Notice of Proposed Amendment 2017-04

Regular update of aerodrome rules

CS-ADR-DSN — Issue 4

RMT.0591

Figure L-10A. Mandatory instruction marking inscription form and proportions

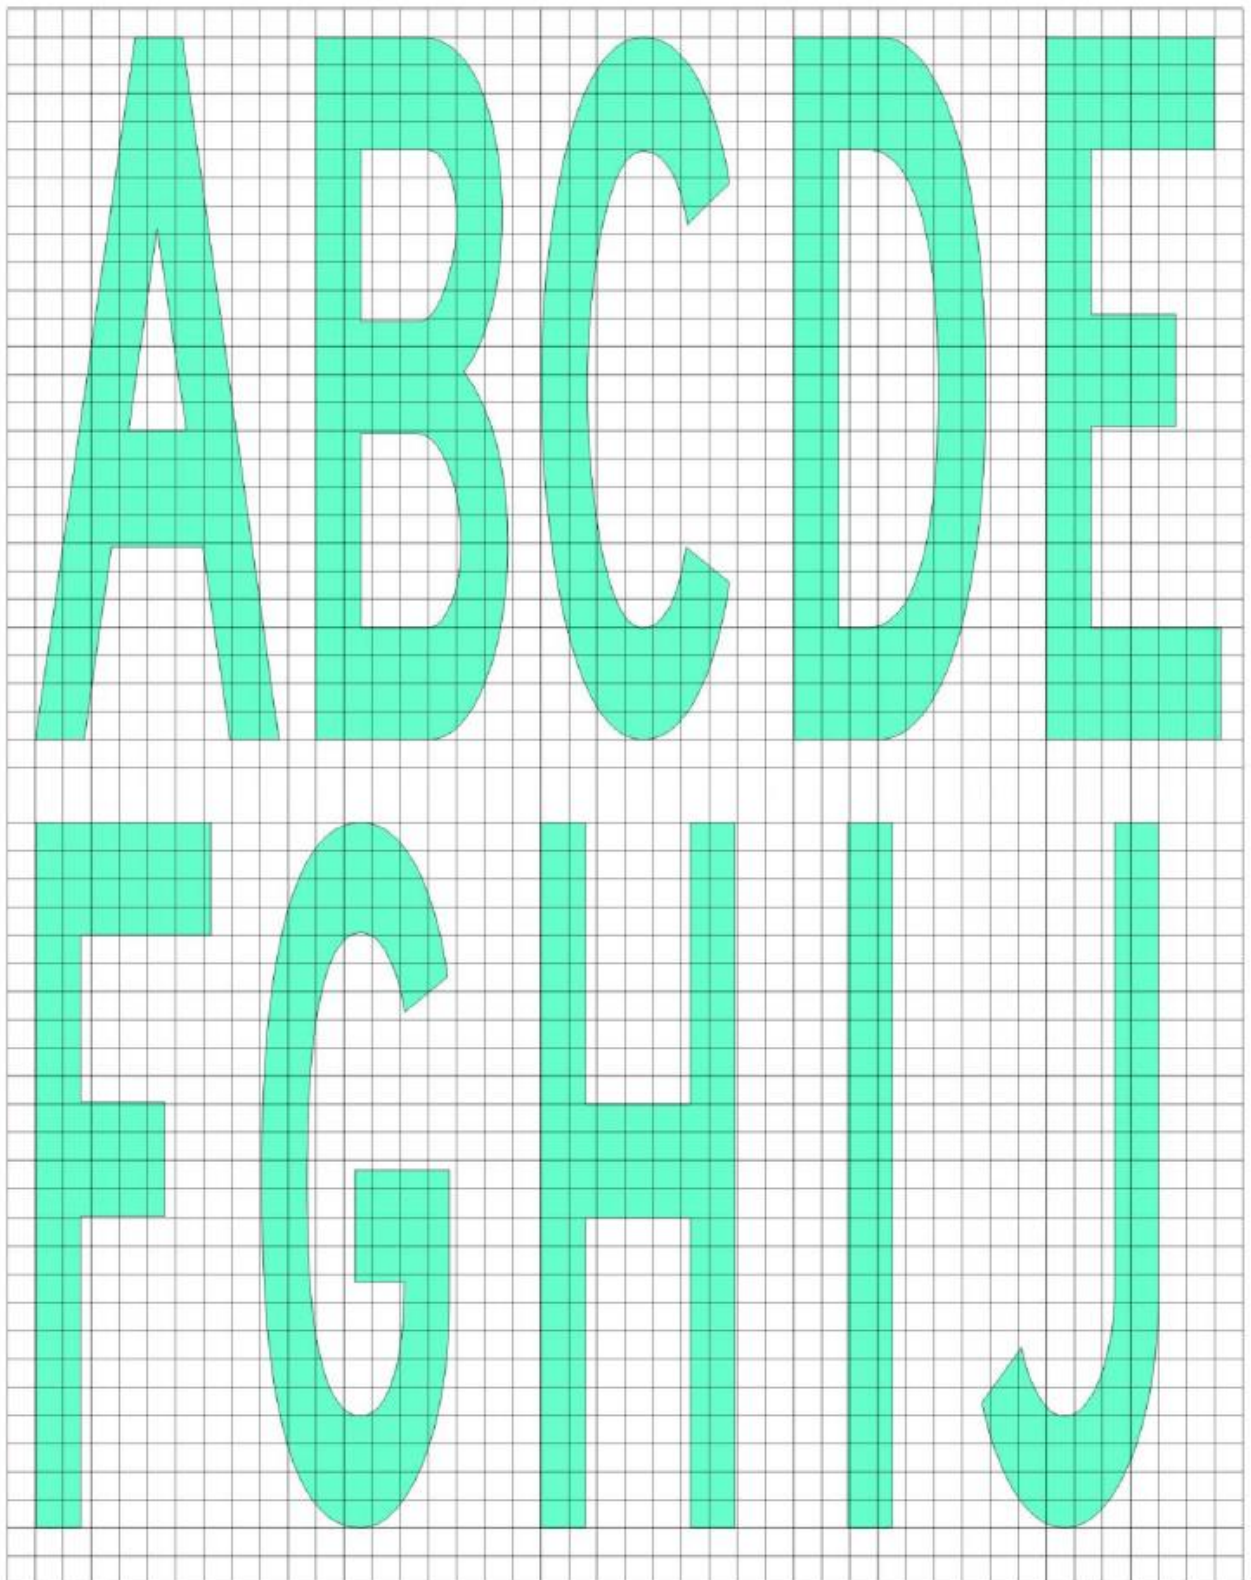
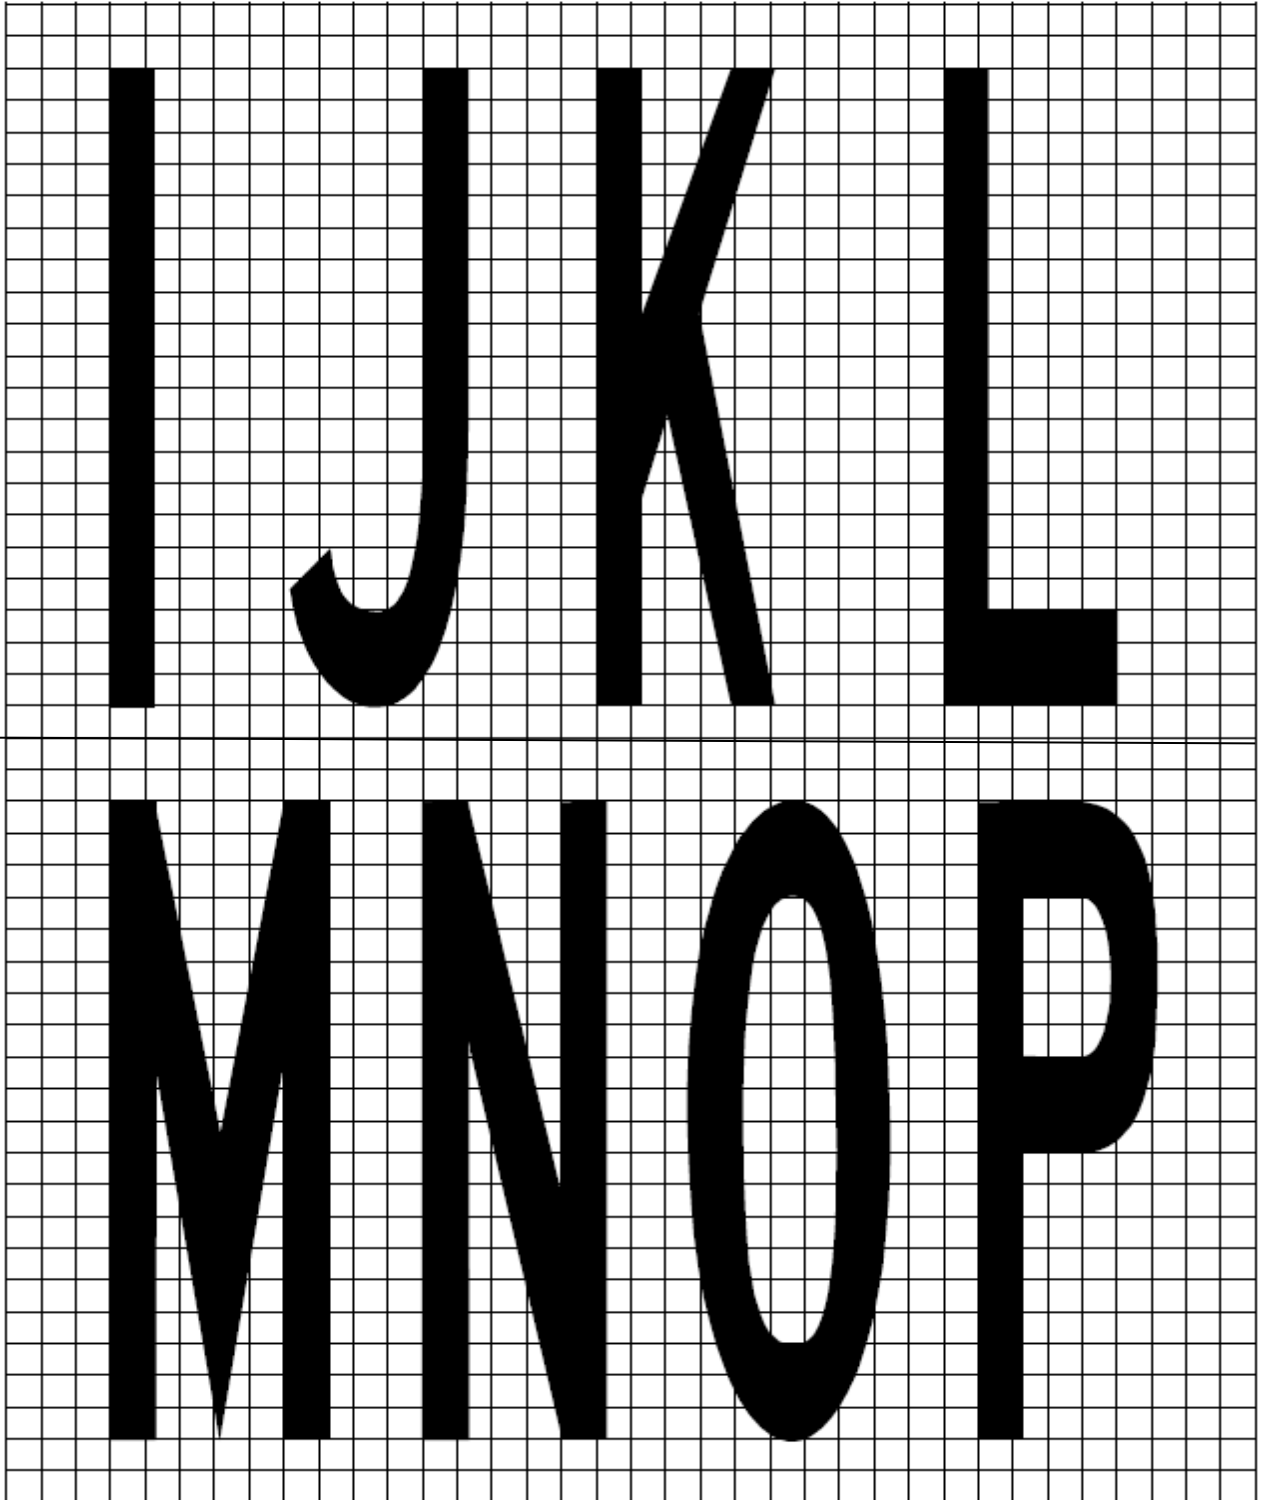
[Editorial note: Figure L-10A is deleted.]

[Editorial note: new Figure L-10A is added as follows:]

Figure L-10B. Mandatory instruction marking inscription form and proportions

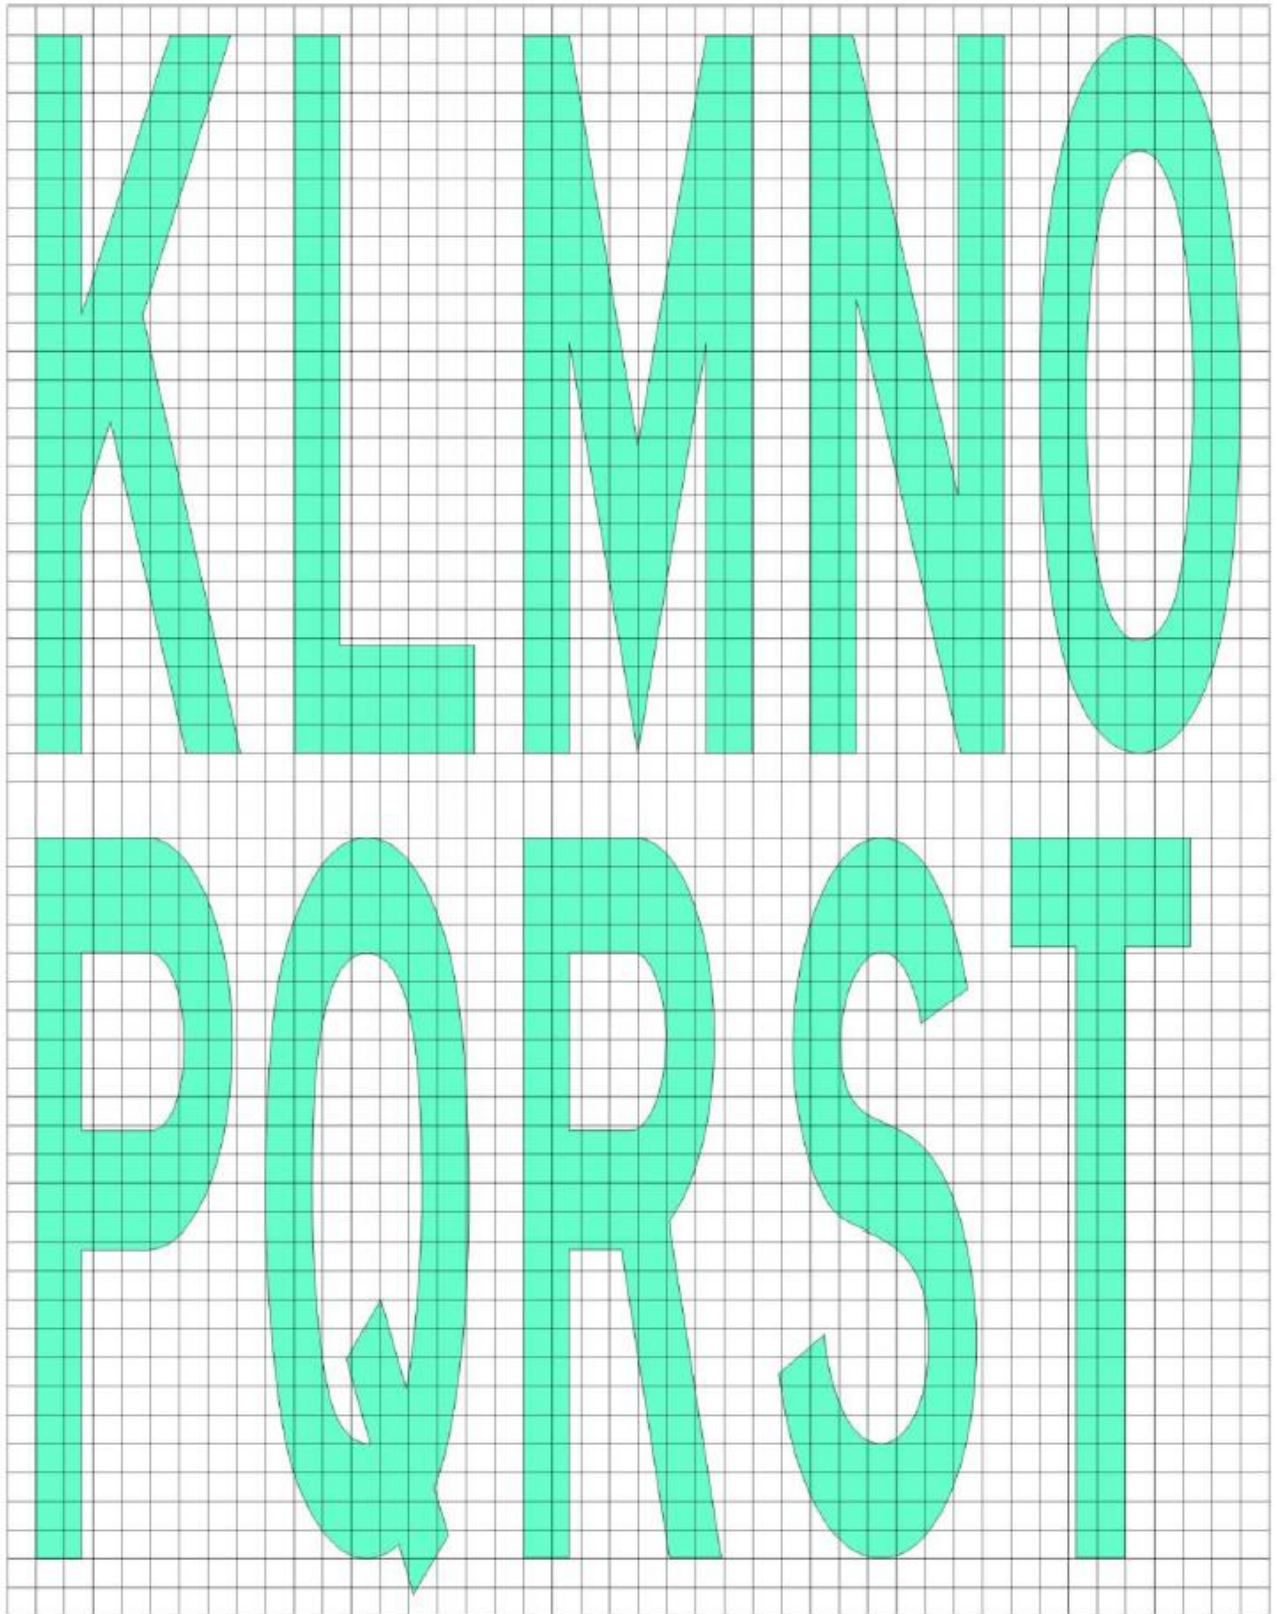
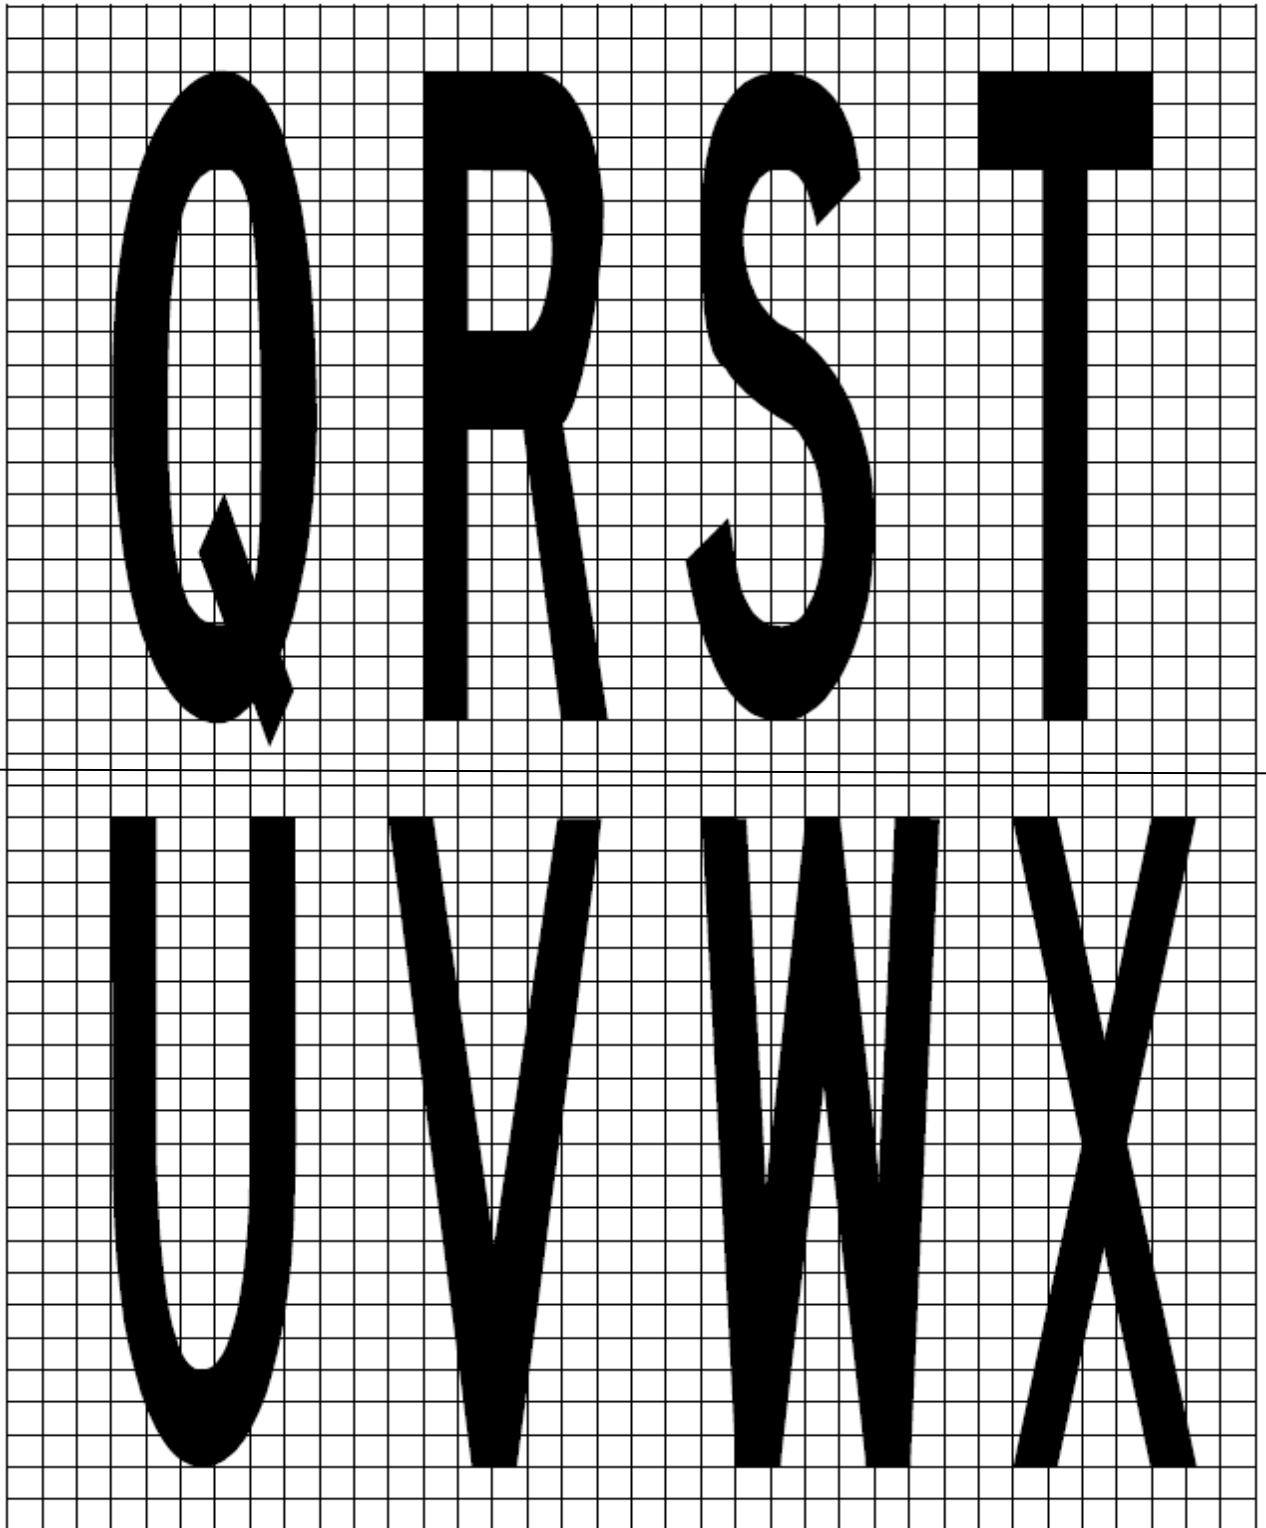
[Editorial note: Figure L-10B is deleted:]

[Editorial note: new Figure L-10B is added as follows:]
